RE: Data Request #4 - Certificate of Public Convenience and Necessity for the Riverside Transmission Reliability Project – Application No. A.15-04-013

REQUEST FOR ADDITIONAL DATA: DATA NEEDS #4 FOR THE RIVERSIDE TRANSMISSION RELIABILITY PROJECT - APPLICATION (A. 15-04-013)

Figure 1: Bellegrave - Pats Ranch Road Underground

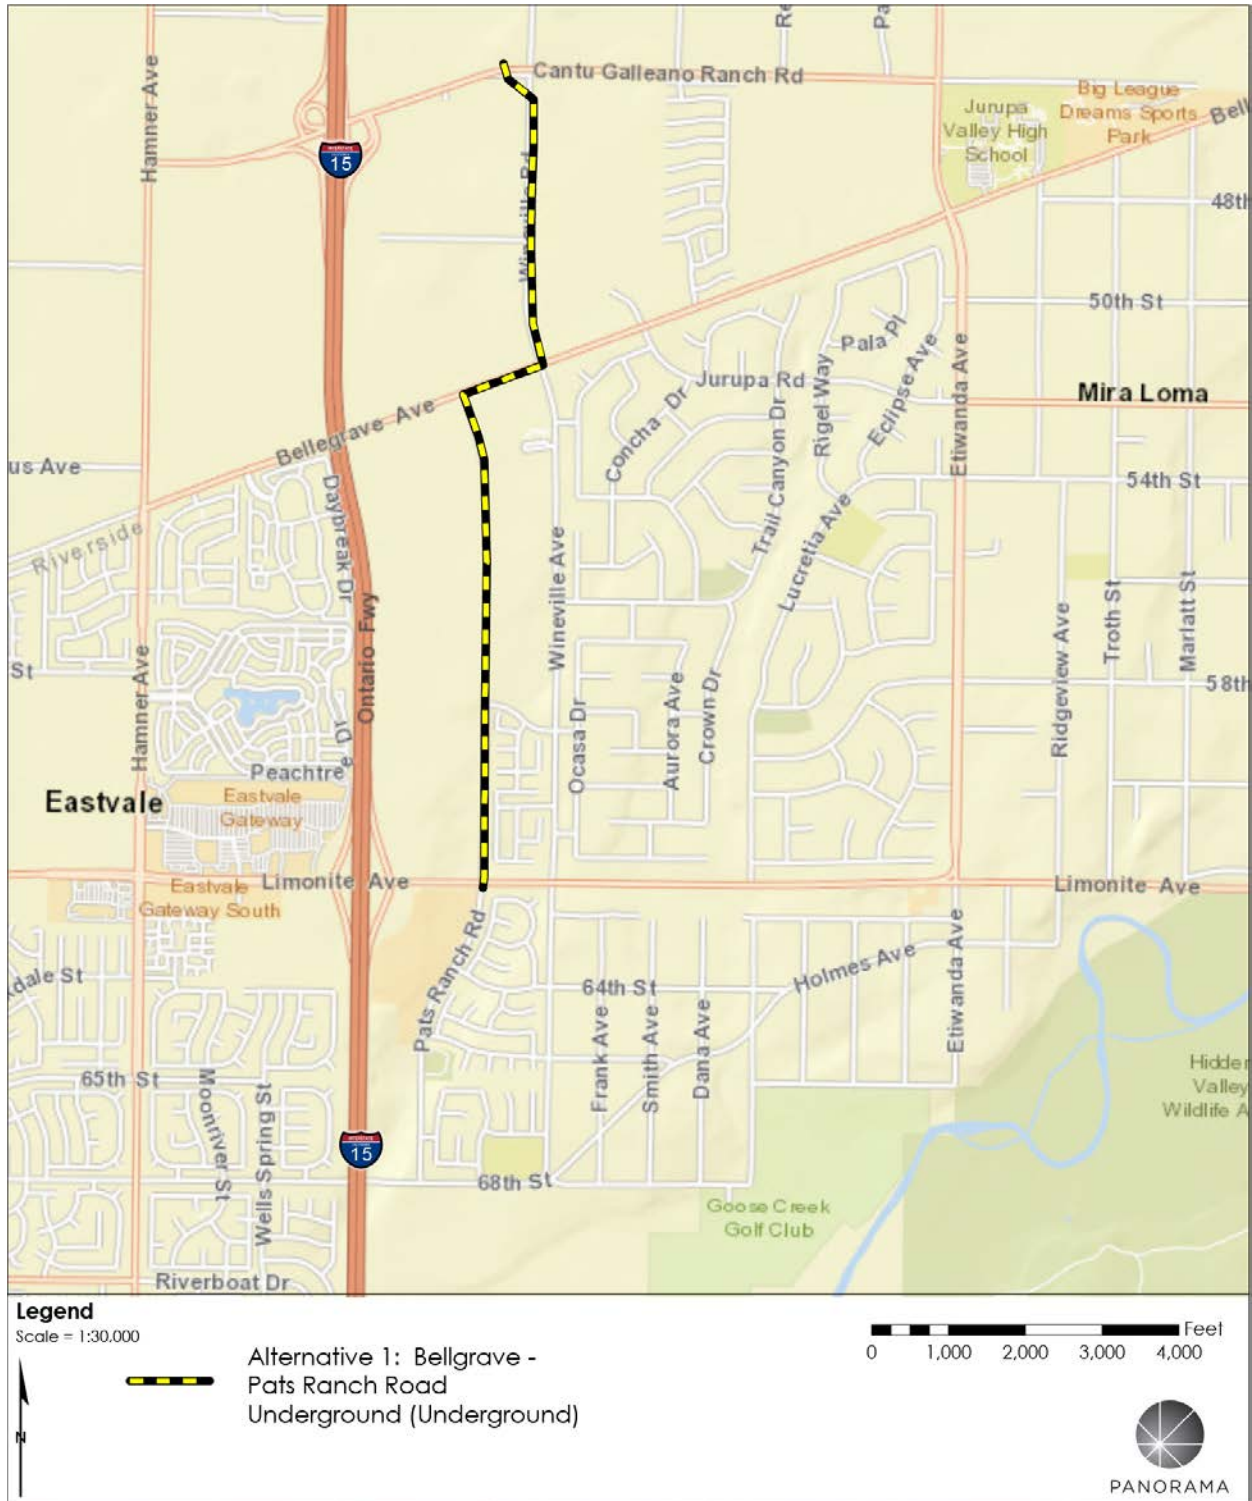
Number	Data Need
Alternatives	
ALT-1	<p>The CPUC requests preliminary engineering for potential alternatives listed below</p> <ol style="list-style-type: none"> 1. Alternative 1: Bellegrave – Pats Ranch Road Underground (see Figure 2). The alternative would transition to an underground position adjacent to the tie-in to Mira Loma – Vista 230 kV #1 Line. The transmission lines would travel south under Wineville Road to Bellegrave Avenue. From this intersection, the lines would travel west under Bellegrave to Pats Ranch Road. At Pats Ranch Road, the lines would turn south and remain underground within the right-of-way for Pats Ranch Road to Limonite Avenue. 2. Alternative 2: Wineville - Limonite Underground (see Figure 3). The alternative would transition to an underground position adjacent to the tie-in to Mira Loma – Vista 230 kV #1 Line. The transmission lines would travel south under Wineville Road to Limonite Avenue. The transmission lines would turn west at Limonite Avenue and remain underground within Limonite Avenue to Pats Ranch Road. 3. Alternative 3: Riser Pole Relocation and Wineville - Landon Underground (see Figure 4). The alternative would transition to an underground position adjacent to the tie-in to Mira Loma – Vista 230 kV #1 Line. The transmission lines would travel south under Wineville Avenue to Landon Drive. The lines would head west under Landon Drive. Just west of the terminus of Landon Drive the lines would transition to overhead. The transmission lines would follow the location of the revised project overhead lines adjacent to the I-15 freeway. Near Limonite Avenue, the riser pole would be relocated approximately 0.25 mile north-northwest of the proposed position and within the revised project alignment. The underground transmission line would follow the revised project alignment underground from the relocated riser pole. <p>The following details shall be provided for each alternative:</p> <ol style="list-style-type: none"> 1. Layout of each alternative: <ol style="list-style-type: none"> a. Indicate approximate location and height of riser poles (transition from overhead to underground).

Number	Data Need
	<ul style="list-style-type: none"> b. General duct bank alignment and minimum lateral spacing between duct banks. c. Indicate preliminary location of splice vaults. <ol style="list-style-type: none"> 2. Number of underground cables per circuit. 3. Number of duct banks per circuit. 4. Duct bank configuration: <ul style="list-style-type: none"> a. Height, b. Width c. Number of ducts d. Depth of burial e. Phase arrangement f. Include approximate size of trench excavation. 5. Type of splice vault, e.g. Pre-cast or CIP. 6. Splice vault size including approximate size of excavation necessary to place vaults. 7. For cut and cover construction method, identify the average and maximum width and length of area to be under construction at a given time. 8. Identify if there are any possible locations where jack and bore or horizontal directional drilling construction methods would be used. If these are to be used, provide construction details such as location and length, size of excavations, etc. 9. EMF modeling for proposed underground circuit configuration for a width of 200 feet. Include any proposed low-cost or no-cost EMF measures consistent with CPUC requirements. 10. Any additional construction staging areas or yards necessary for the identified alternatives. 11. Anticipated total construction duration for the underground portion of alternatives.
